Project	IEEE 802.16 Broadband Wireless Access Working Group < http://ieee802.org/16 >	
Title	Femtocell Base Station State Diagram	
Date Submitted	2009-04-24	
Source(s)	Andreas Mäder, Linghang Fan, Tetsu Ikeda NEC	E-mail: andreas.maeder@nw.neclab.eu linghan.fan@eu.nec.com t-ikeda@ap.jp.nec.com
Re:	Category: SDD comments / Area: Chapter 15 (Femtocell)	
Abstract	The contribution provides a clarifying state diagram for femtocell base stations	
Purpose	To be discussed and adopted by TGm for the 802.16m SDD	
Notice	<i>This document does not represent the agreed views of the IEEE 802.16 Working Group or any of its subgroups. It represents only the views of the participants listed in the "Source(s)" field above. It is offered as a basis for discussion. It is not binding on the contributor(s), who reserve(s) the right to add, amend or withdraw material contained herein.</i>	
Release	The contributor grants a free, irrevocable license to the IEEE to incorporate material contained in this contribution, and any modifications thereof, in the creation of an IEEE Standards publication; to copyright in the IEEE's name any IEEE Standards publication even though it may include portions of this contri

Figure XX: State transition diagram of Femtocell BSs

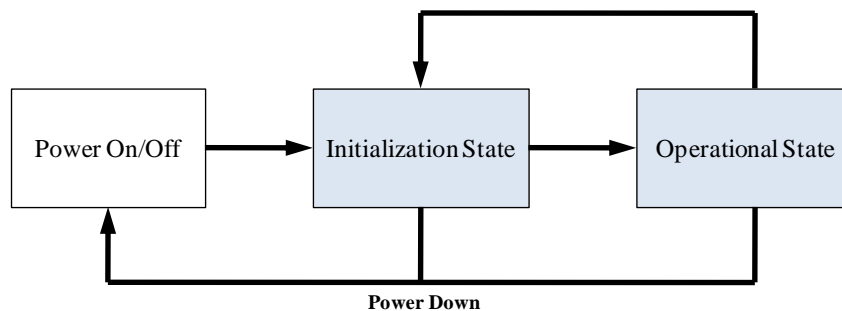
Low duty mode has been introduced in the femtocell operation. However, the relationship among different modes in the femtocell BS is not very clear. It would be beneficial to define the state diagram to illustrate the transition among different states in the femtocell BS.

Insert the following text into the “Support for Femto” clause (IEEE 802.16m-08/003r8):

Figure XX illustrates the Femtocell BS state diagram. The state diagram contains an initialization and operational state.
